Seattle
Design
Commission

APPROVED
MINUTES OF THE MEETING
15 April 2004

15 April 2004 Project: Cal Anderson Park: Phase IV (Lincoln Reservoir)

Phase: Schematic Design Update

Phase 4 Improvements

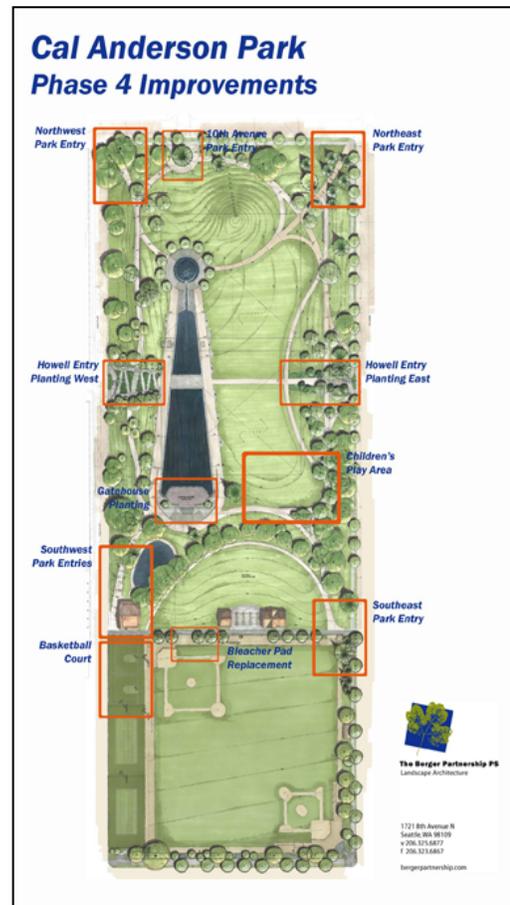
- **Look again at the NW Denny entrance wall relationships and the way they compare to the other entrances, especially the paving, and try to make it similar to the others;**

- **Questions the placement of the playground and cautions it might be an intrusion into the lawn. Check the geometry to make sure that it does not overly impact the shape of the overall proposed design;**

- **Questions the unnecessary removal of trees and cluttering of design elements near some of the entries;**
- **Questions whether the SE entrance is generous enough to be viable without the curb extension or bulb-out;**

- Proponent noted the opportunity to relate the water feature to the play area perhaps through the utilization of the on-site reservoir.
- Would like clarification as to why the granite wall inside the Northwest entry is located in a different location than the other three entries.

- Proponent stated that the Chinese Scholar Tree prevents similar placement of the wall, and interferes with natural circulation through the entry.
- Stated that there should be an elimination of the granite wall in the Northwest entry if its placement is different than the other three, or perhaps the geometry of the wall and plantings should be shifted to open up the entry.

- Concerned that the proponents have overdone some features of the design. Suggested that the proponents should take out anything that is not necessary near the entrances.

- Proponents acknowledge that there may be a better way of handling the termination of the primary open space.
- Are concerned that the absence of a Southeast entrance bulb-out creates a tight and awkward space.
